VEHICLE RECALL

G-05506 April 2005

SUBJECT: SAFETY RECALL (Canada, EXPORT)

The Entrance Door Pin on certain CE school bus models built between 11-18-2004 and 02-10-2005

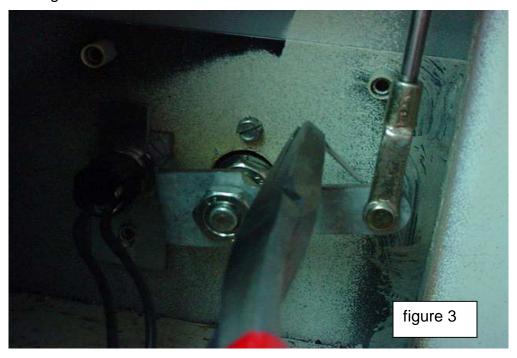
During assembly, a spring pin may have been substituted for the cotter pin retainer in the exterior locking control of some Canadian CE school buses built with an optional external entrance door control.

The spring pin could slip out of place and jam the operation of the door lever, preventing the door from being opened from the outside or inside of the bus. This jamming of the door may occur without warning, and may result in an unreasonable risk to motor vehicle safety. This involves evacuation concerns relating to people transport.

- 3. Remove button cap and screw with retaining nut on backside. See Figure 1.
- **4.** Remove dash to expose cable assembly.
- 5. Remove Spring Pin. See figure 2.

6. Replace spring pin with cotter pin and spread ends to prevent extraction. See figure 3.
